## TECHNICAL SERVICE BULLETIN

### Lariat - Snow Plow/Start-Stop Deactivation Buttons - Incorrect Button Illumination

**20-2385**  
02 November 2020

<b>Ford</b> 2020 F-150
---------------------------

Figure 1

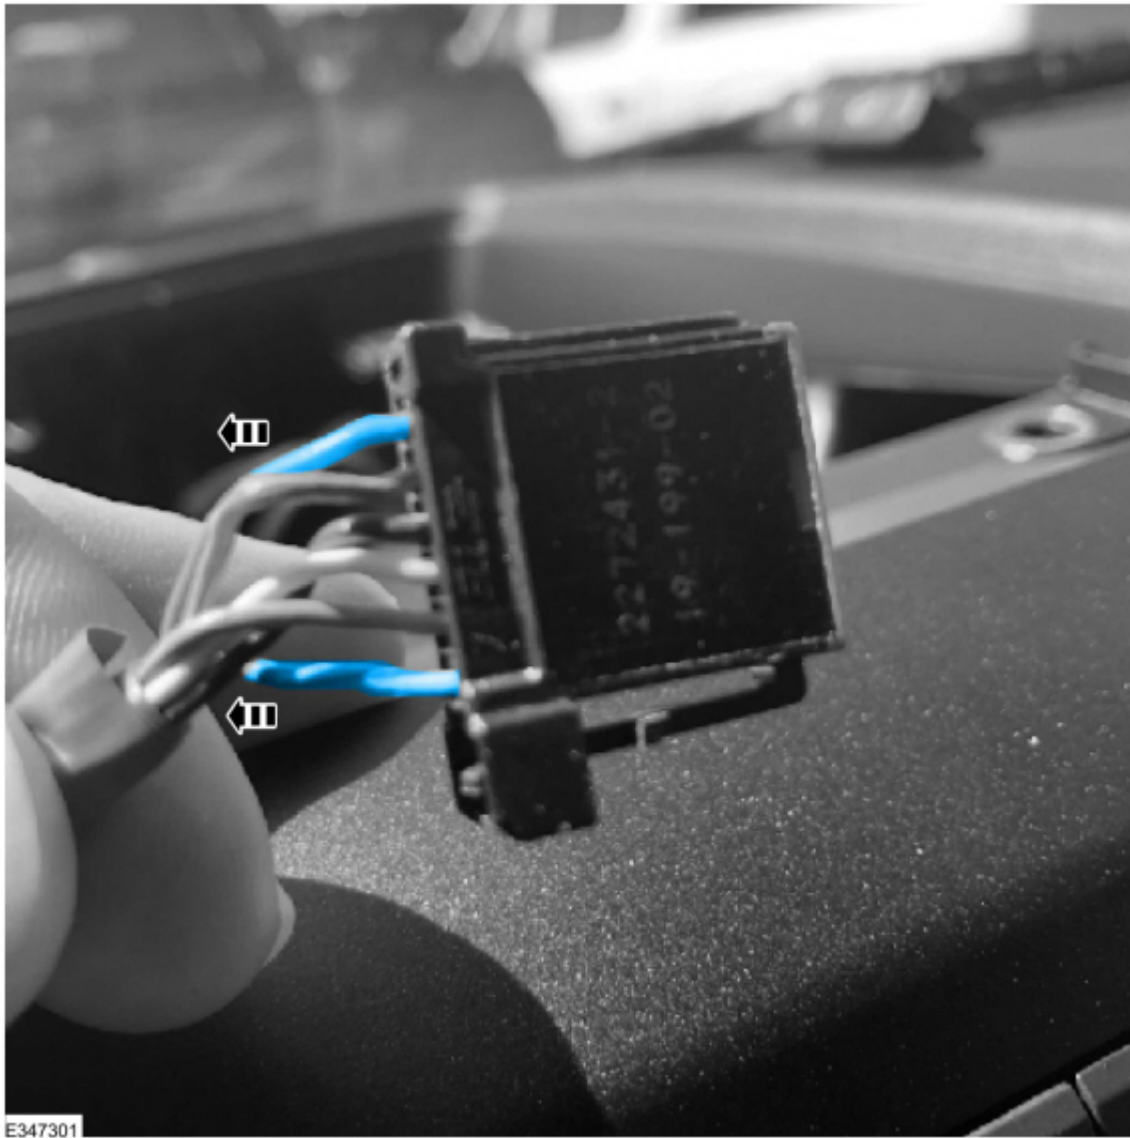
1. Remove the front controls interface module (FCIM). Refer to Workshop Manual, Section 415-00C.
2. Disconnect connector C2480 from the start/stop deactivation and snow plow mode button.
3. Remove pins #1 and #6 from connector C2480. (Figure 1)

Figure 2

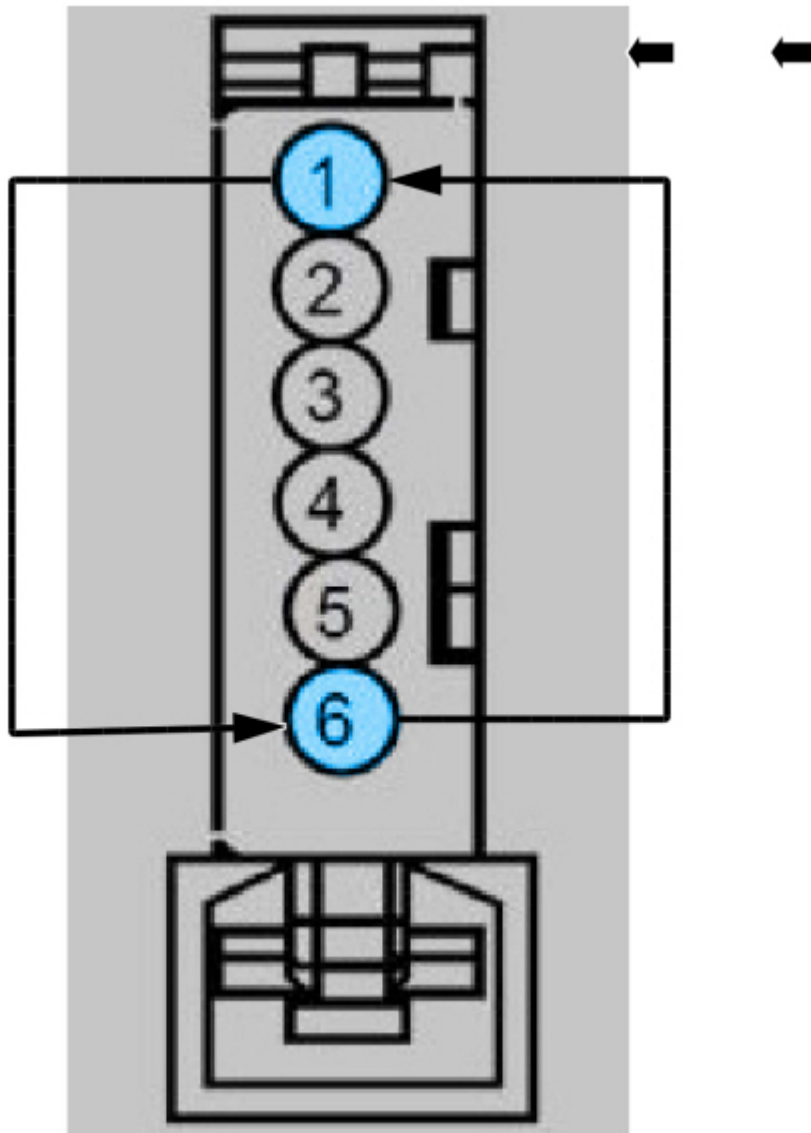
4. Reinstall the pins into the opposite positions, so the BN wire (circuit CE469) is in location 6 and the GY-BU wire (circuit CPD02) is in location 1. (Figure 2)
